SSDA Mods

1.1 Facade Materiality

Modification 1 to SSDA

Cox Architects

Proposed: South Elevation [SMCSWSPS-FOS-OSN-AT-DWG-960002 Rev E]

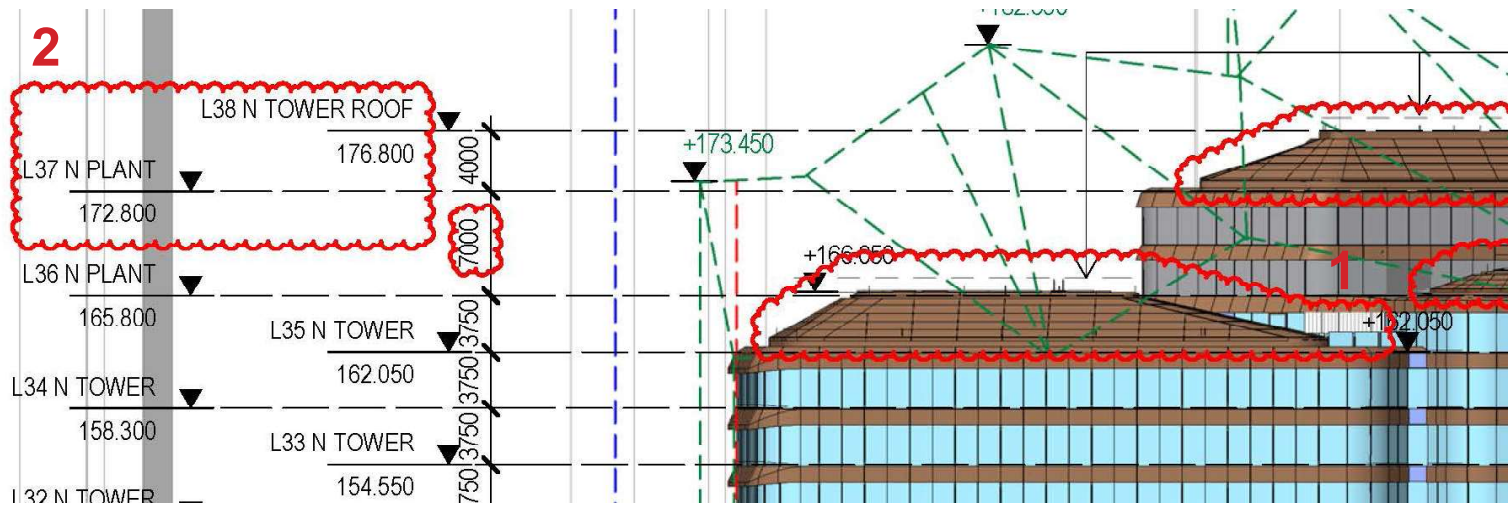
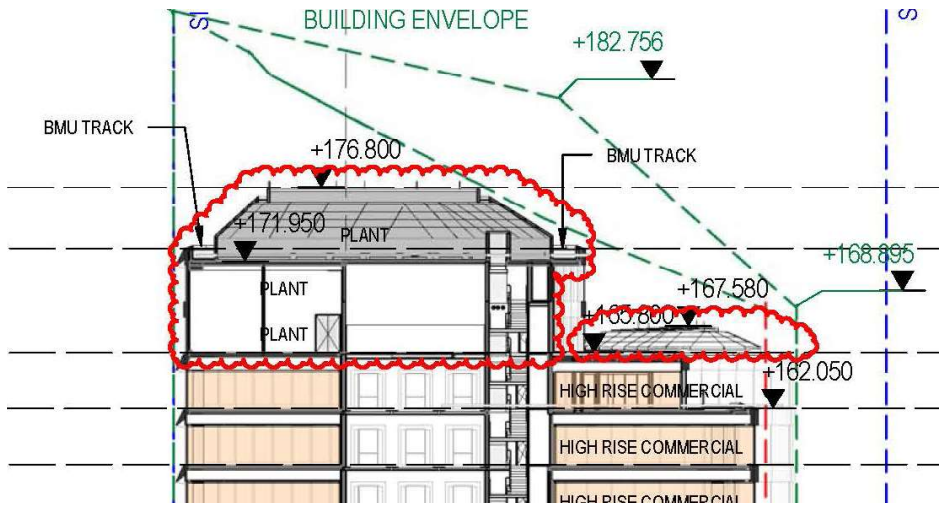
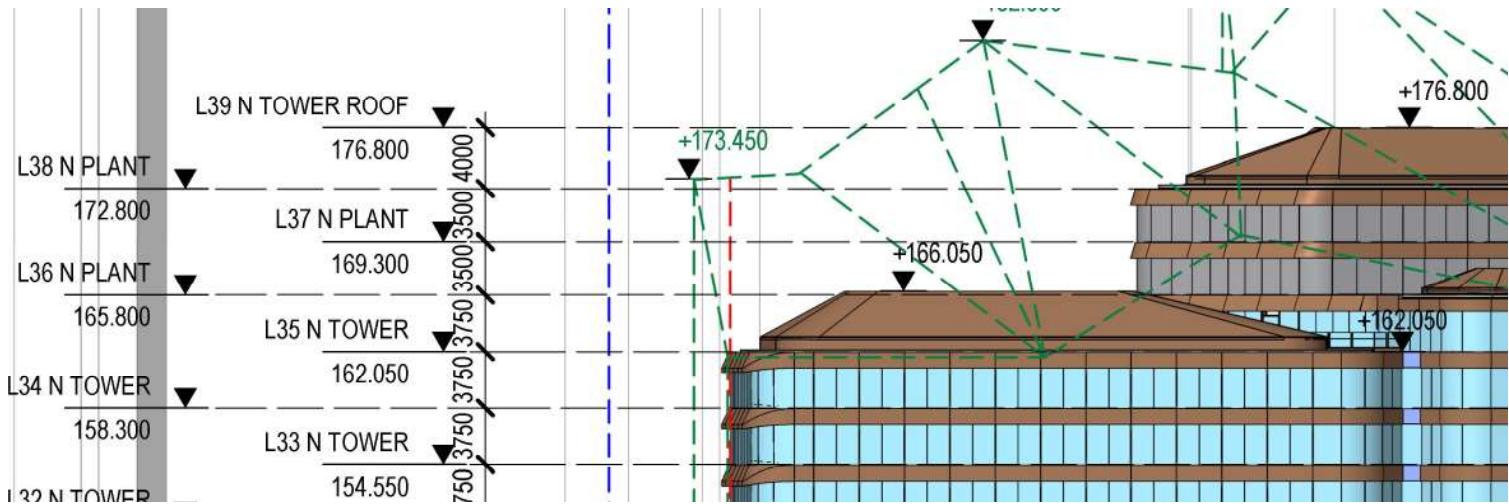
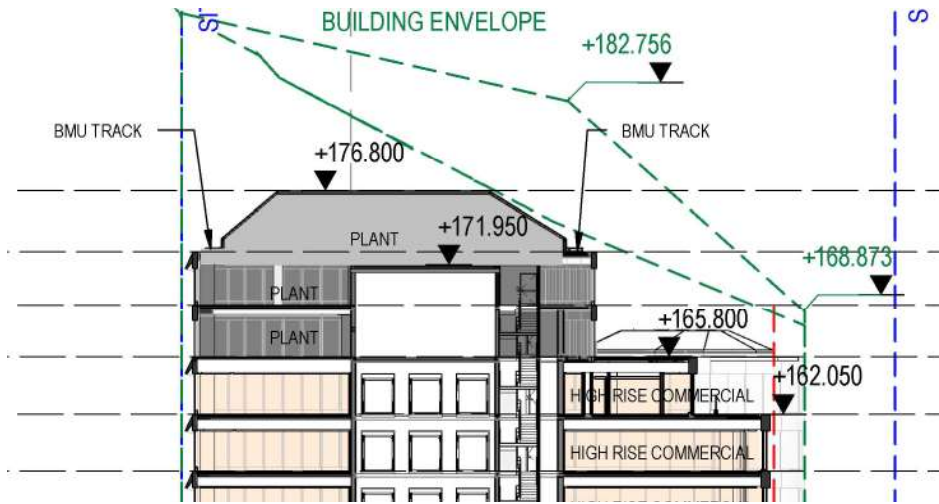
1. A correction has been made to the south western roof facade (level 35) show the fluted glazing for the toilet amenities. This change is a graphical fix as illustrated.

2. Roof Project Levels have been updated.

Previous Level 37 has been removed as there are no plant rooms on this level. The slab shown on this level is not needed and is now a void, however the height has been maintained.

Previous level 38 is now named level 37. Previous level 39 is now named level 38. This in no way effects the form of the roof.

1. Approved General Arrangement Elevation West Elevation – Pitt Street (with missing north- south façade identified in red)

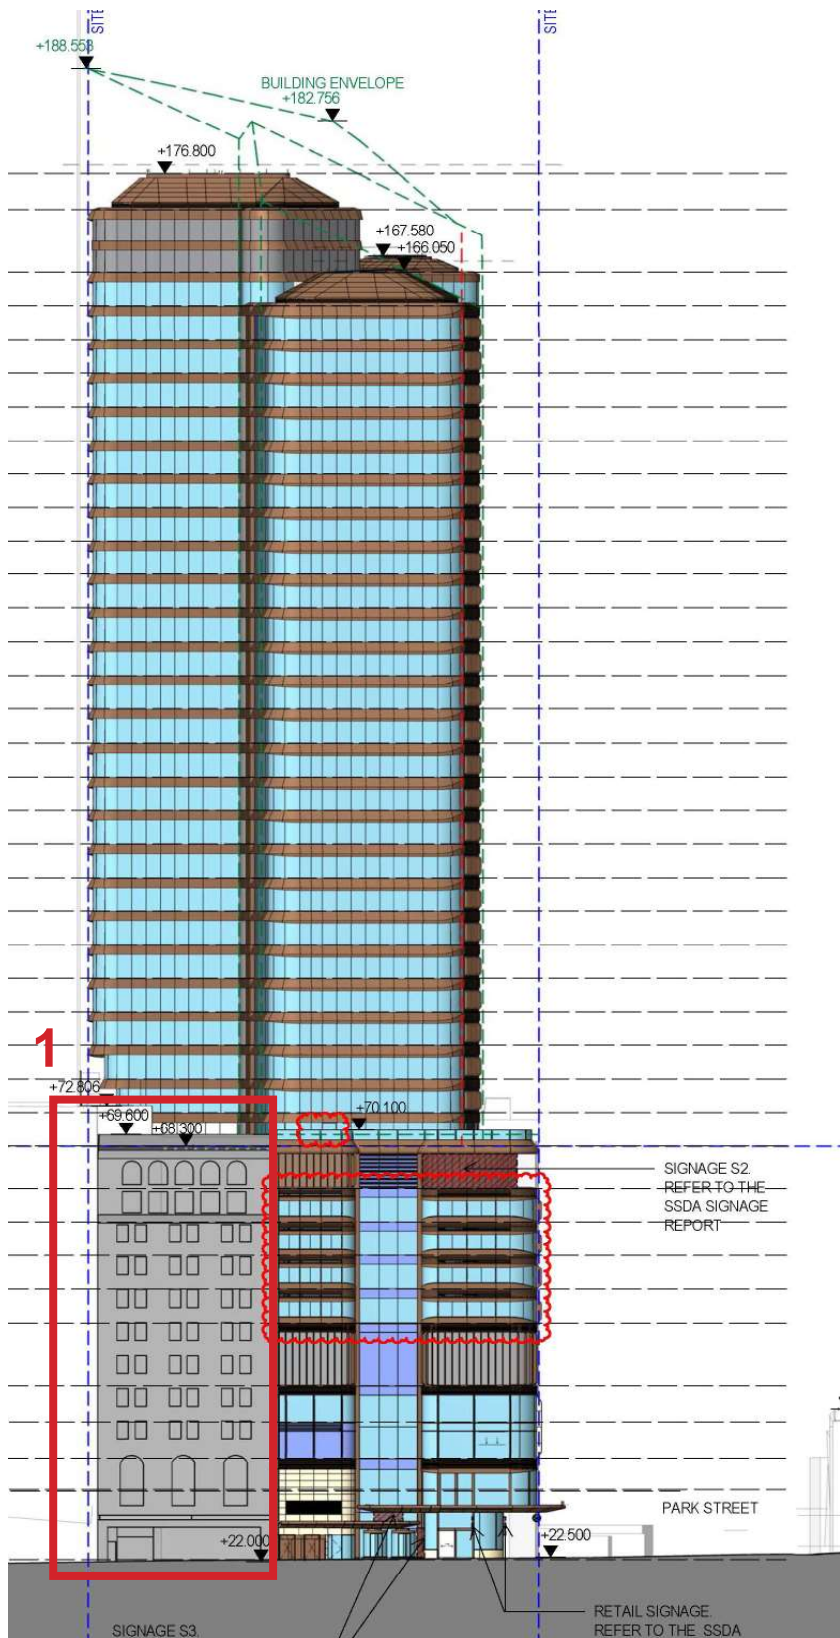
The north western façade of the OSD podium was not included in the approved General Arrangement Elevation West Elevation - Pitt Street Plan (drawing SMCSWSPS-FOS-OSN-AT-DWG-960001) as illustrated.

It is proposed to include an additional plan West Elevation - Ashington Place Lightwell (SMCSWSPS-FOS-OSN-AT-DWG-960005).

Proposed Modification: West Elevation - Ashington Place Lightwell
[SMCSWSPS-FOS-OSN-AT-DWG-960005 Rev A]

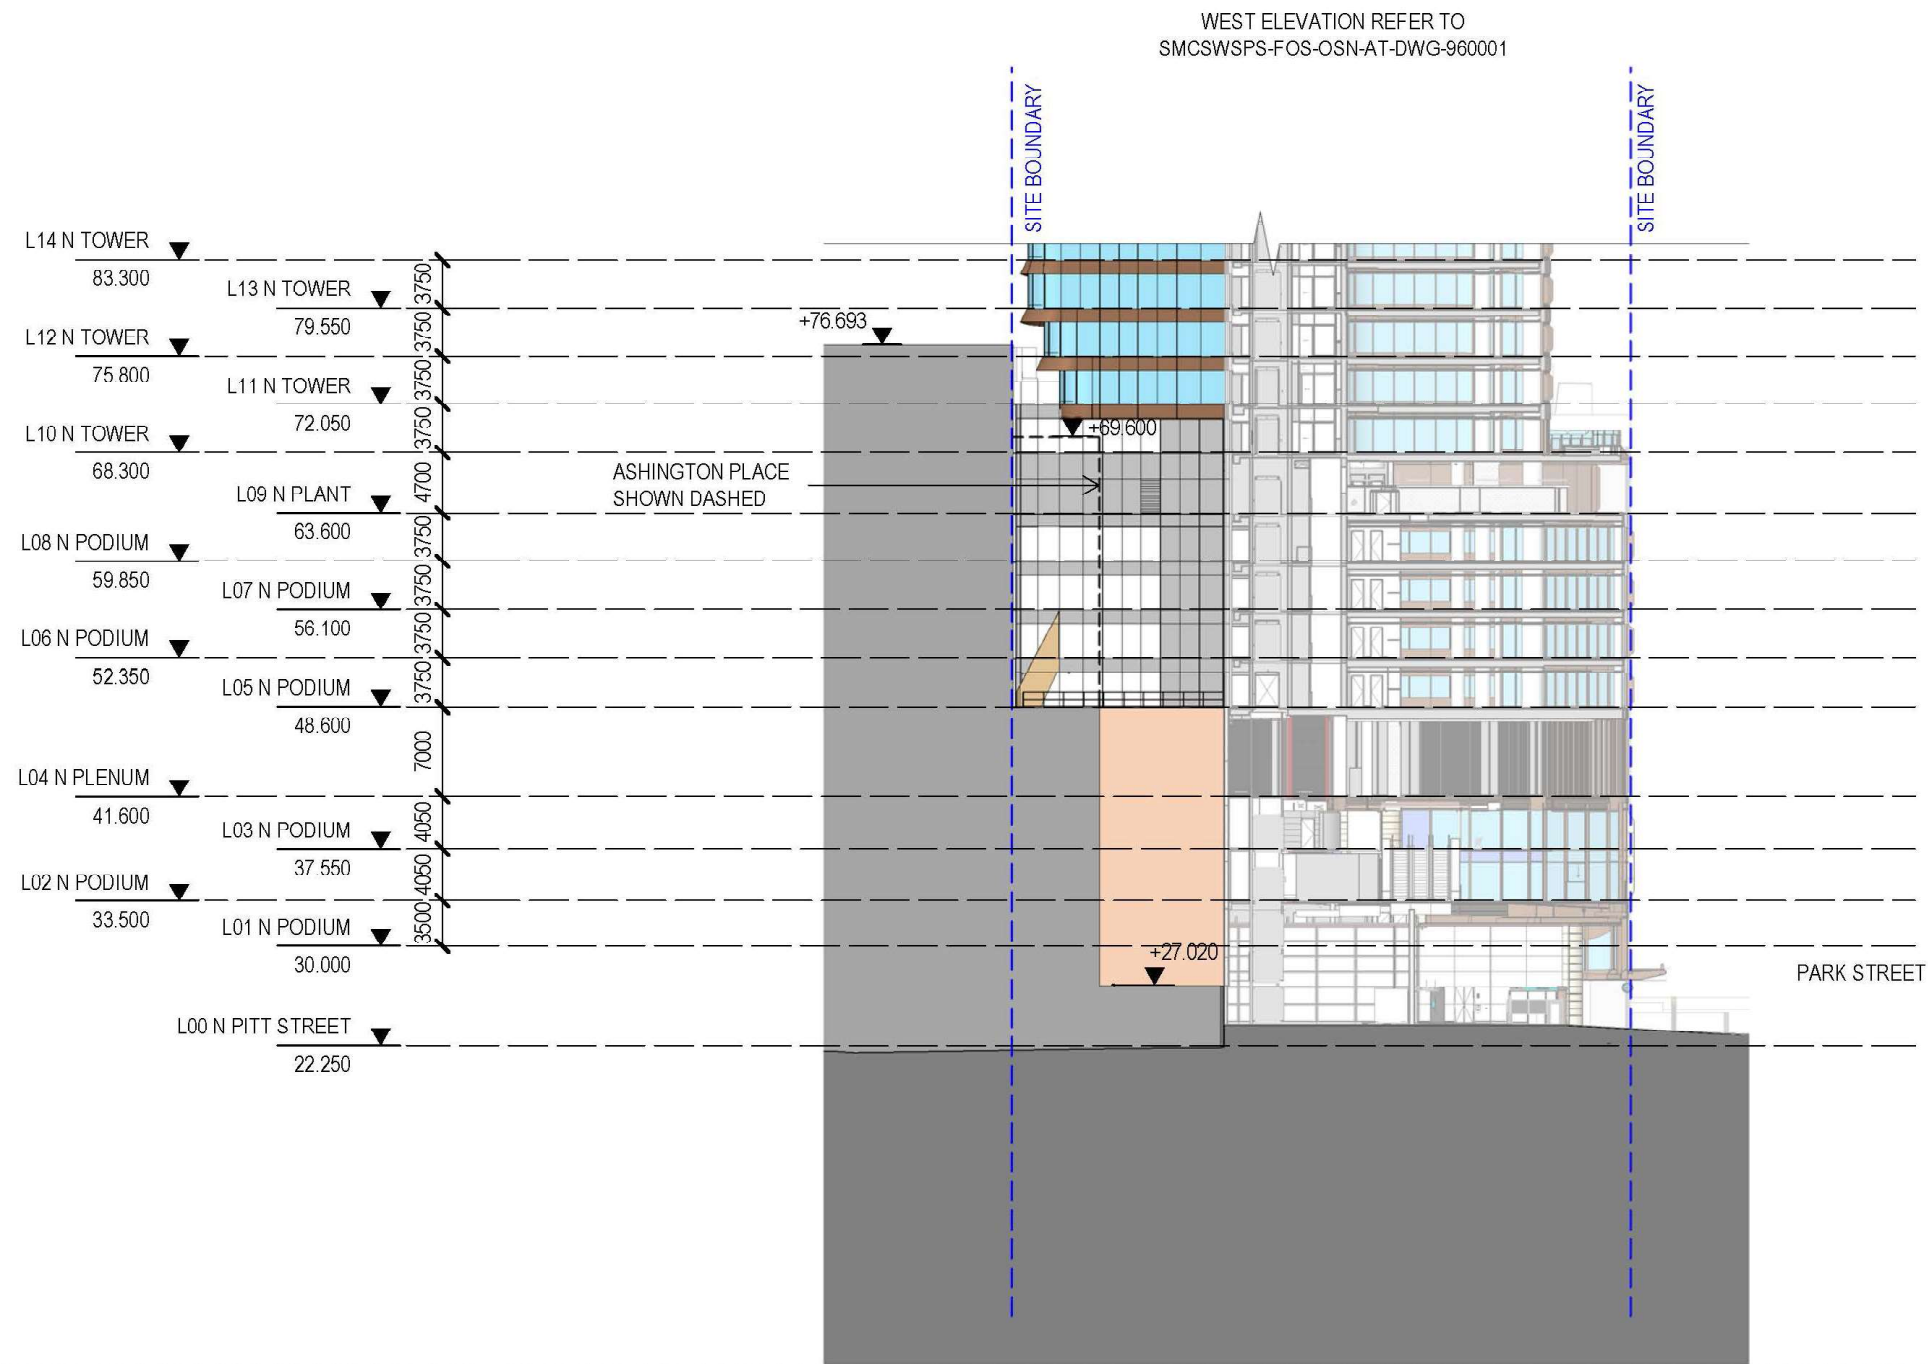
It is proposed to include an additional plan West Elevation - Ashington Place Lightwell (SMCSWSPS-FOS-OSN-AT-DWG-960005).

The proposed elevation cladding is consistent with the intent of the cladding shown on the north elevation lightwells. The adoption of translucent glass where office facades are located is an enhancement to the privacy of the development occupants and the neighbouring occupants.

Tower Facade L10 – Access to the terrace

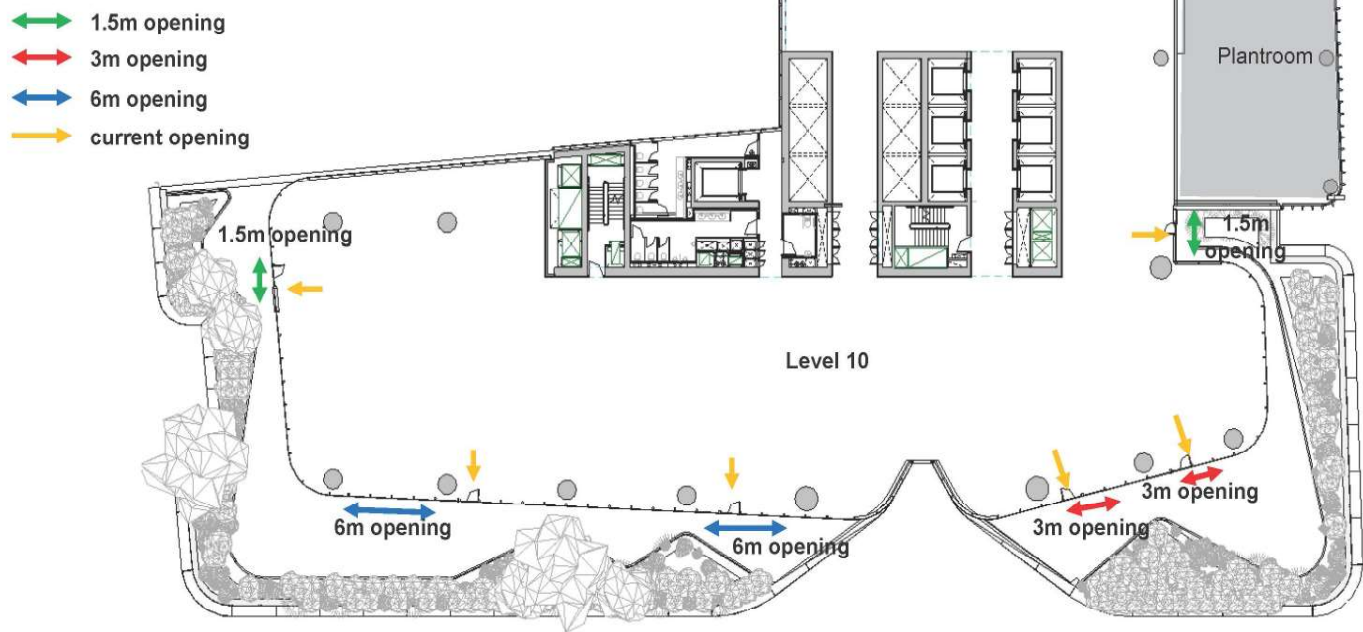
It is proposed to modify the Level 10 and Level 11 terrace door openings.

Terrace doors on Level 10 and 11 have been modified from single width swing doors to sliding doors to improve amenity of the tower, usability and access of the terrace areas.

L10 Transom and Mullion

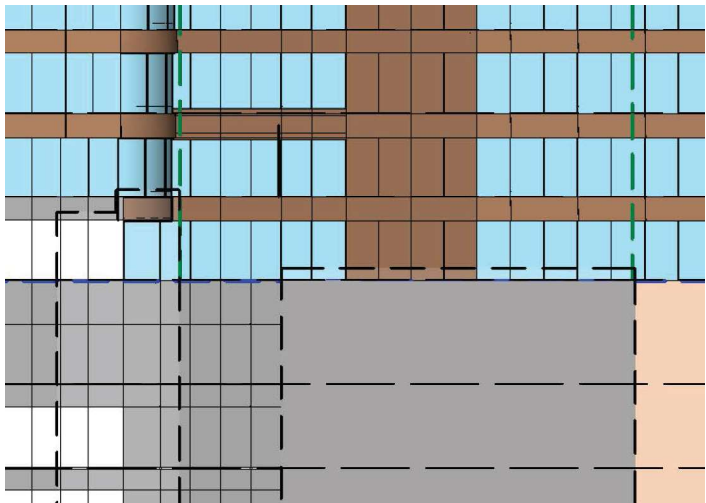
The Level 10 horizontal transom (Facing the Northern Boundary) is adjusted as a development modification to allow for required waterproofing between the proposed development and existing neighbouring buildings.

The proposed modification will not result in any fixture being secured to Ashington Place which protrudes into the PSN site. Sealant will be applied to prevent water seeping in between the PSN OSD and Ashington Place Structures.

The modification will result in an improved look from Level 10 of the OSD. This will also assist in facade maintenance in this location.

Proposed Modification: Modification to L10 Transom

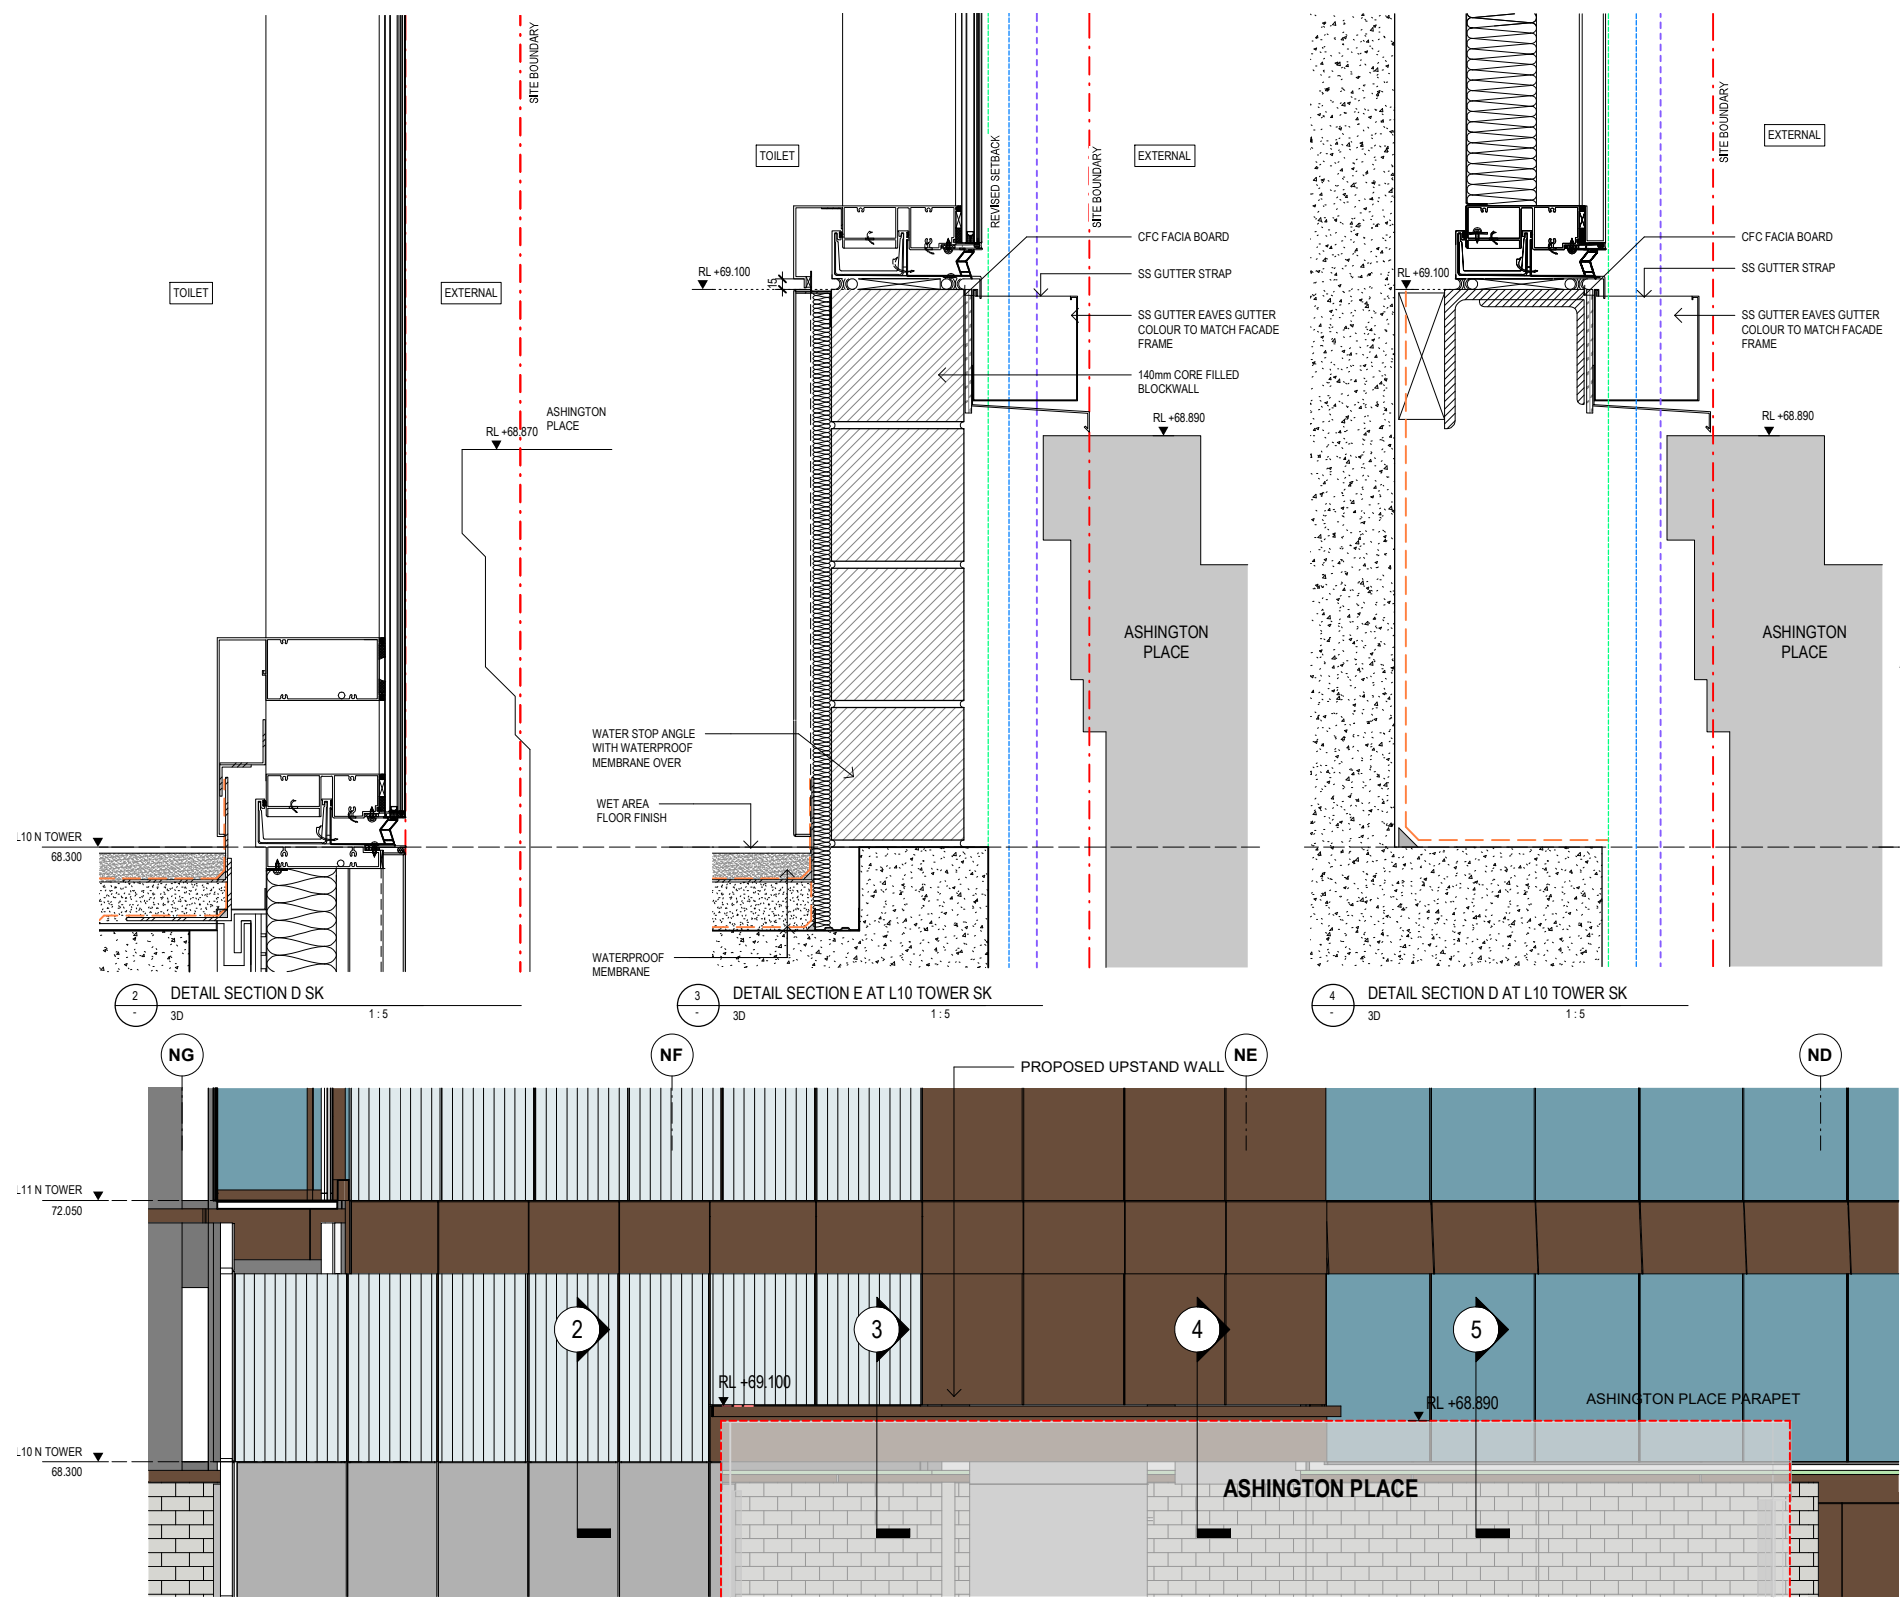
MULLION SHIFTED EAST
APPLIED UPTO LEVEL 5-10.
4x FACADE BAYS EQUALLY
SPACED

GUTTER TO COLLECT
RUNOFF AWAY FROM
ADJOINING NEIGHBOUR

STACK JOINT

VERTICAL FLASHING TO
ASHINGTON PLACE FACADE

The proposed modification will not result in any fixture being secured to Ashington Place which protrudes into the PSN site as per the detailed illustration.
